Standards Governing the Design of Curbside Mailboxes

ACTION: Notice of proposed revision of standards; invitation to comment.

SUMMARY: The Postal Service proposes to replace USPS STD 7B, which governs the design of curbside mailboxes, with new USPS STD 7C. The proposed new STD 7C was developed internally to meet the operational requirements of the Postal Service.

NON-LOCKED MAILBOX
(FULL SERVICE)
FIGURE 1B

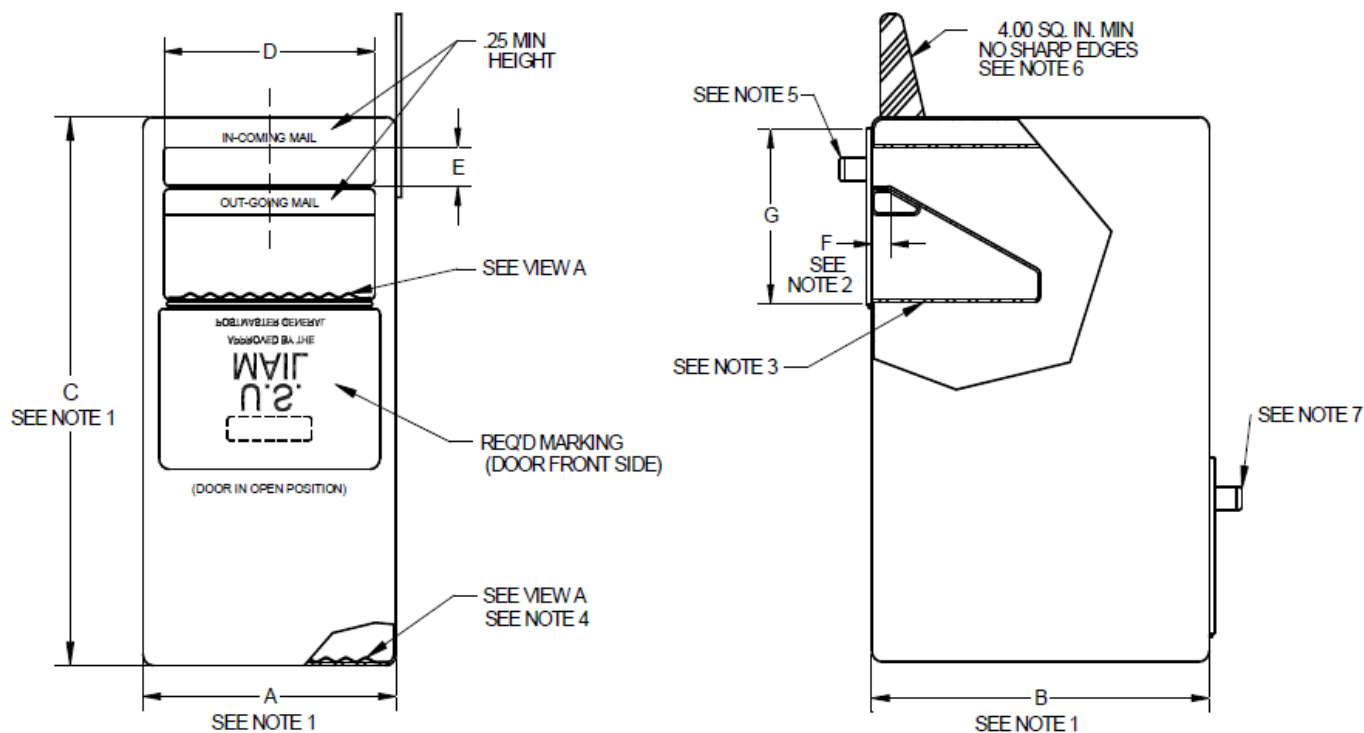
2. Adds new Figures 1B and 3 for the new enhanced capacity non-locked and locked mailbox design options. These figures provide overall design parameters for the two new mailbox design options and the figures are not mandatory design templates.

3.1.1.3 *Large Capacity Designs (Limited and Full Service)* – Mailbox designs that conform to Figure 1B and meet the expanded capacity requirements specified in 4.2.2 will be classified as Large Capacity (LC).

LOCKED MAILBOX
(FULL SERVICE SHOWN)
FIGURE 3

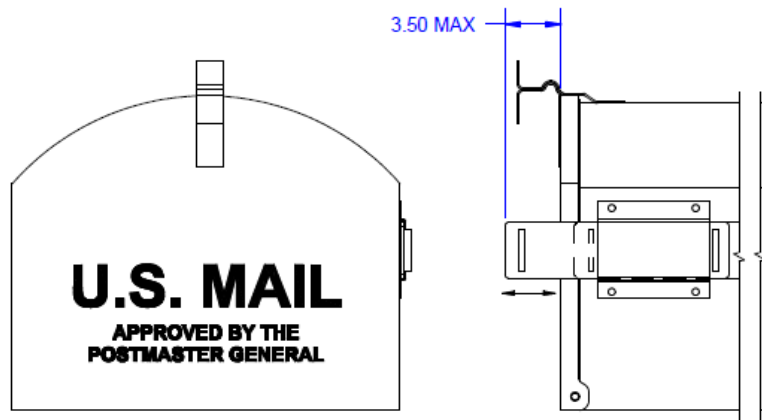
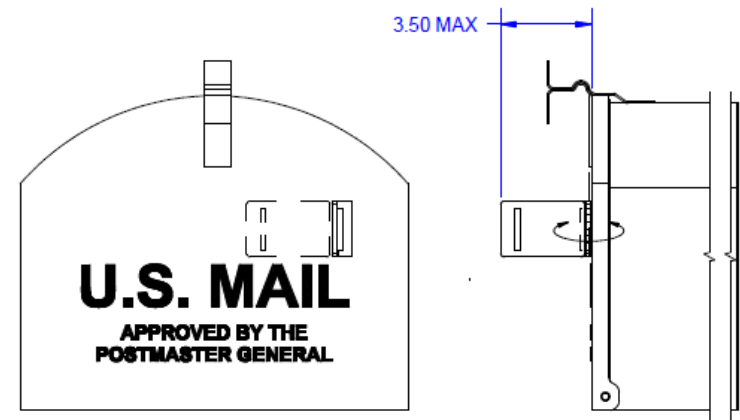
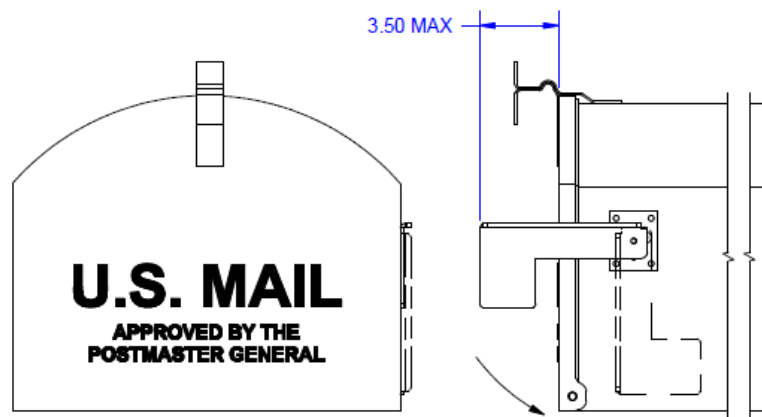
3.1.2.2 *Locked, Large Capacity/USPS-Security-Tested Designs (Limited and Full Service)* – Mailbox designs that conform to Figure 3 and meet both the expanded capacity requirements specified in 4.2.2 and security testing specified in 4.12 will be classified as Locked, Large Capacity/USPS-Security-Tested (LLC).

3.1.2.2.1 *Full Service* – Locked mailbox designs of this class allow for both incoming and outgoing mail as depicted in Figure 3. Both incoming and outgoing mail functionality must be located behind a single carrier service door as shown in Figure 3. While it is preferred¹ that the outgoing mail function be handled via use of the backside of the front door, any alternate use of a separate outgoing mail compartment, such as beneath or side-by-side with the incoming mail compartment, is permitted provided that no additional carrier service is introduced. All designs must allow the carrier direct access to grasp and retrieve the outgoing mail.
